Re: Varna Wind Inc. Leave to Construct Application
Board File No. EB-2012-0442
Interrogatories of the Applicant on Ritzema and Oldfield Evidence

Interrogatories of the Applicant on Ritzema and Oldfield Evidence

EXHIBIT A

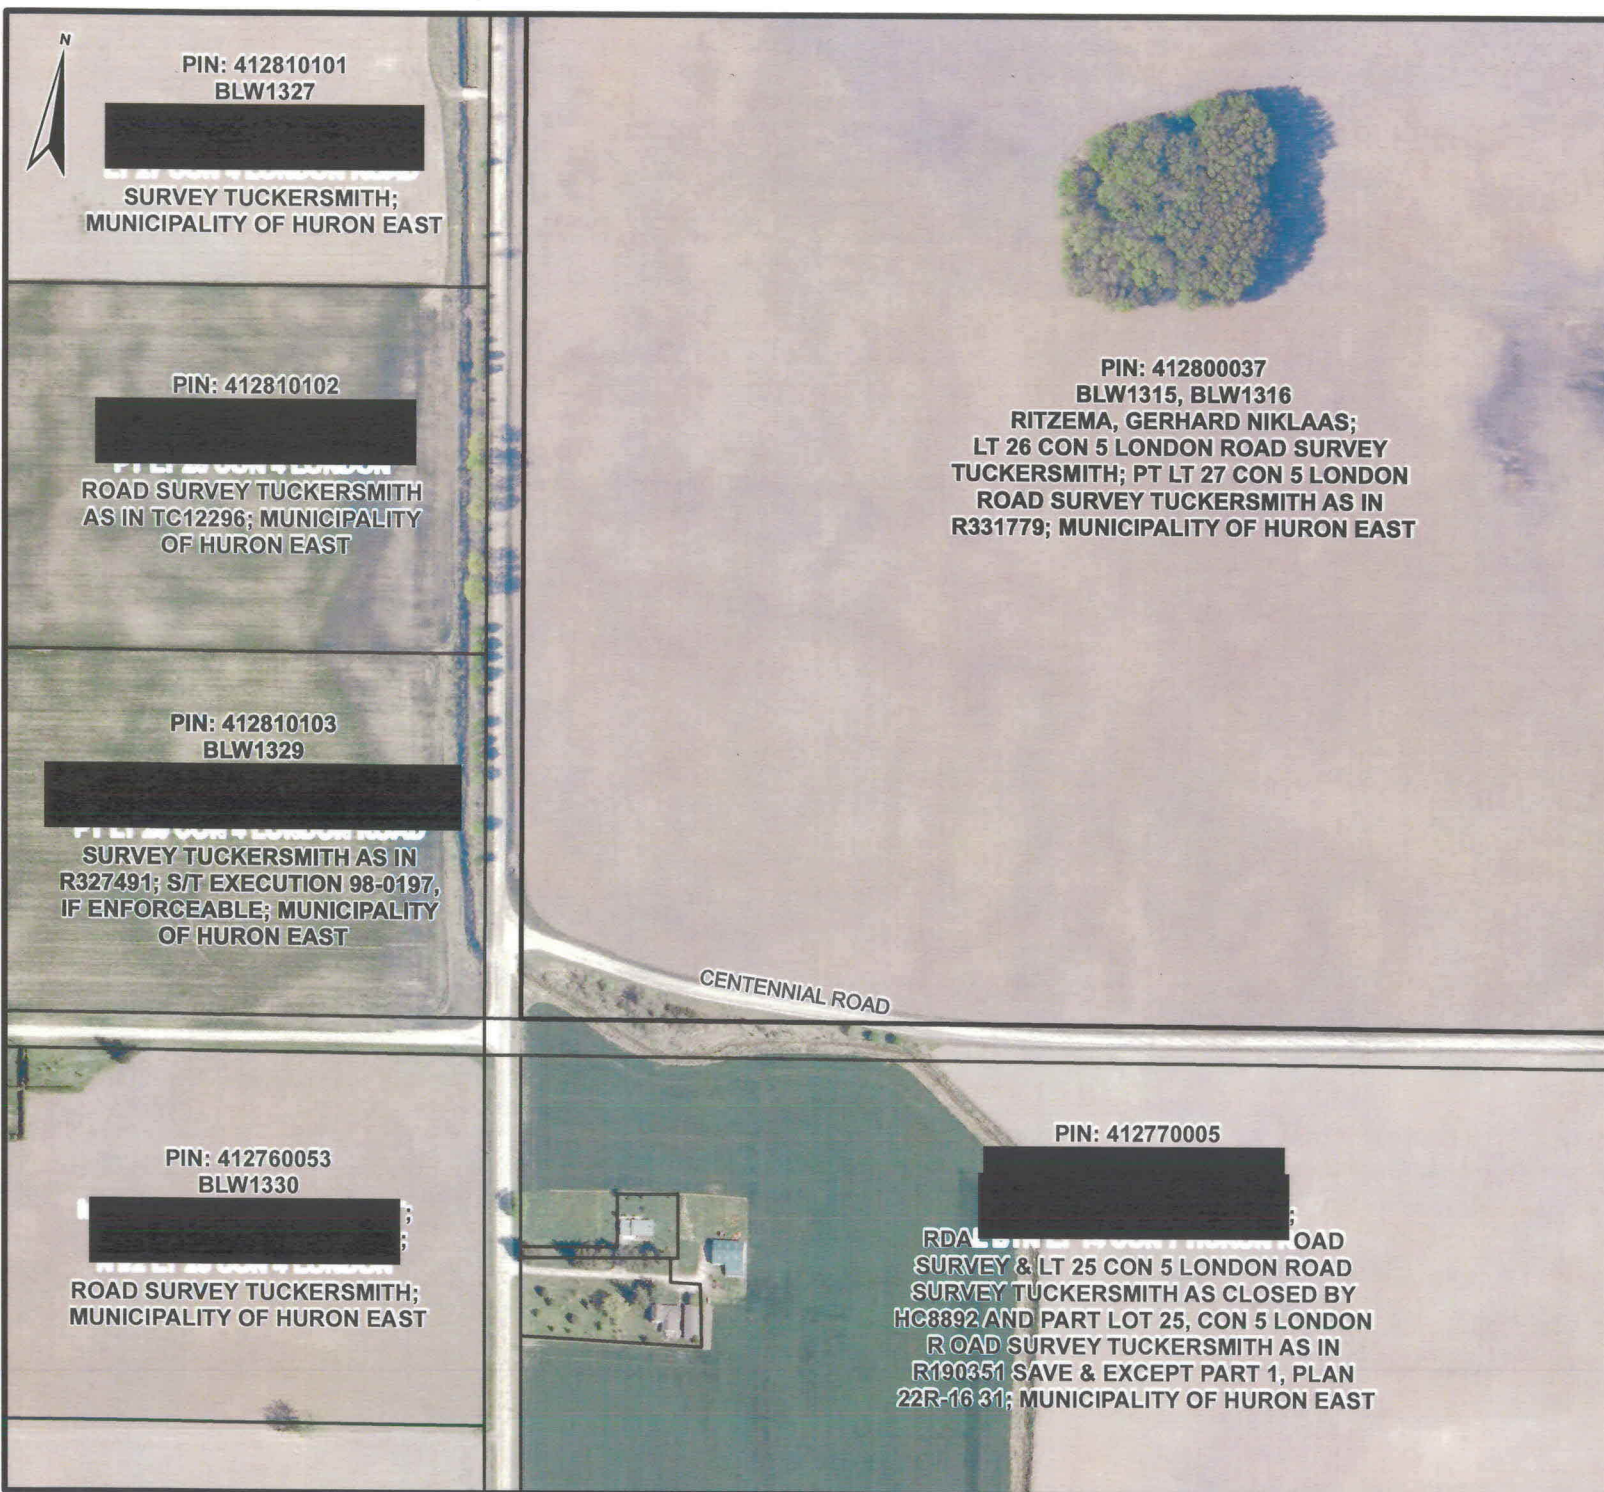
Exhibit 4 of the Ritzema evidence is a Google map showing how Centennial Road slopes northward and connects with Division Line. Attached as Exhibit A to these Interrogatories is a version of that map that includes registered owners (redacted) and the existing municipal right of way. Exhibit A demonstrates that Centennial Road deviates north of the right of way prior to

its connection at Division Line. The area in the triangle in between the right of way and Centennial Road is the same as the area which is cross hatched in pink at Exhibit 4 of the Ritzema evidence. That area will be referred to in these Interrogatories as the "Deviation Area" and the portion of Centennial Road in the Deviation Area will be referred to as the "Deviation Road".

4. Please advise whether the Ritzemas agree with the contents of the map at Exhibit A.
5. Did the Ritzemas or the predecessor to Mr. Ritzema in title to PIN 41280-0037(LT), being Lot 26, Concession 5, London Road Survey Tuckersmith; and part Lot 27, Concession 5, London road Survey Tuckersmith as in R331779; Huron East; open the Deviation Road in the place of the original road allowance that is in the Deviation Area?

6. Did the Ritzemas or the predecessor to Mr. Ritzema in title ever receive compensation for the land comprising the Deviation Road?
7. Is Mr. Ritzema now the person in possession of the portion of the original road allowance that is in the Deviation Area, particularly having regard to Exhibit A, which shows that a significant portion of the Deviation Area is farmed contiguously with land to the south of the Deviation Area owned by the neighbours to the south? If not Mr. Ritzema, then who is in possession of that land?
